Subject: Fuel Leak Case No. RO0000409 and Geotracker Global ID T0600102279, Unocal #1156, 4276 MacArthur Boulevard, Oakland, CA 94619 – Conditional Work Plan Approval

Alameda County Environmental Health (ACEH) staff has reviewed the fuel leak case file for the above-referenced site, including the recently submitted document entitled, "*Work Plan for Additional Site Assessment Investigation, 76 Service station, 4276 MacArthur Blvd., Oakland, CA,*" dated March 1, 2010 (Work Plan). The Work Plan, which was prepared in on behalf of ConocoPhillips by Delta Environmental, proposes soil vapor, soil, and groundwater sampling to address data gaps in the current site conceptual model.

Attachment: Additional Soil Vapor Wells

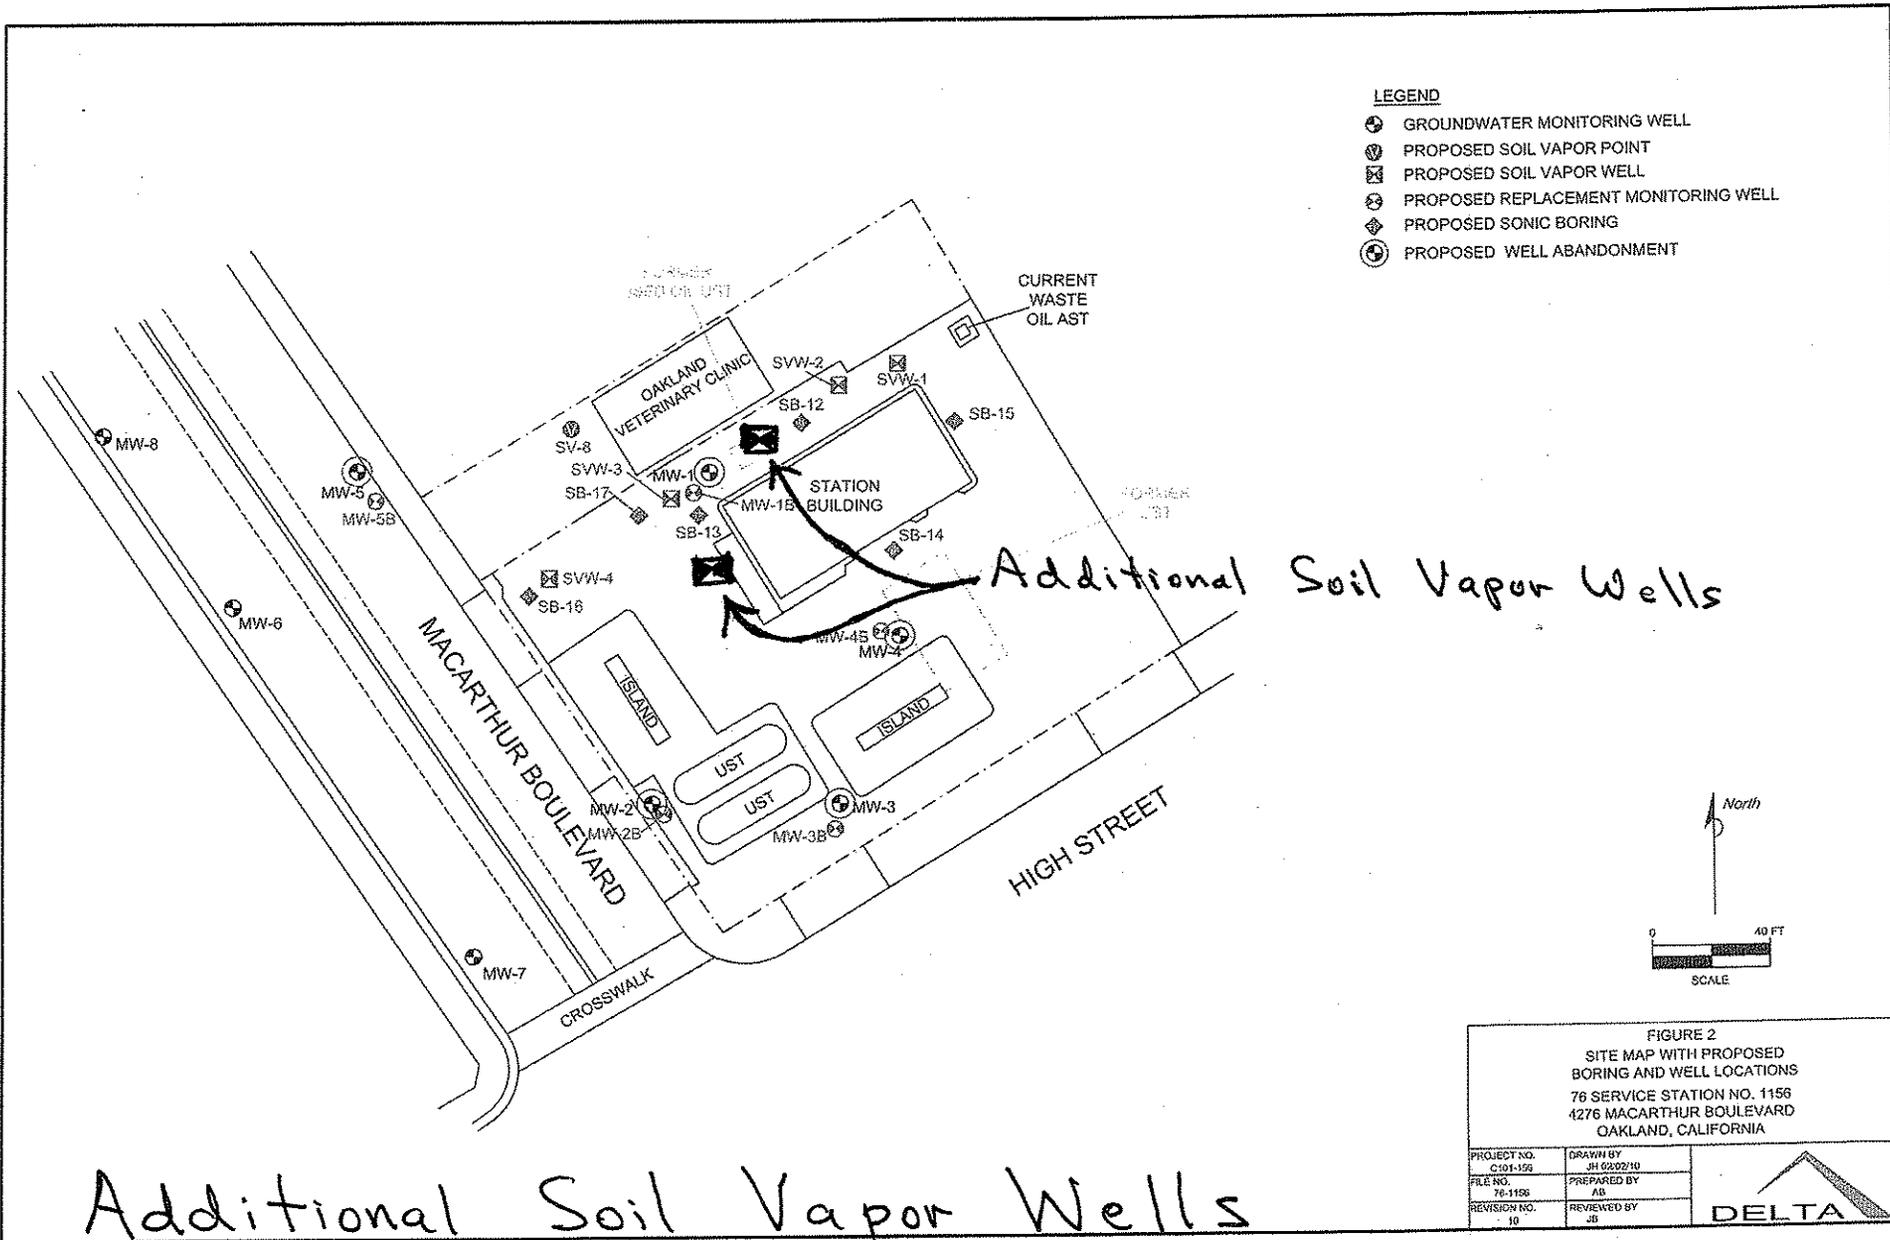
- 1. Soil Vapor Sampling.** The proposed soil vapor sampling locations and methods are generally acceptable. However, we request that you include two additional soil vapor wells as shown on the attached figure entitled, "Additional Soil Vapor Wells." Please include soil vapor sampling results in the Site Assessment Report requested below.
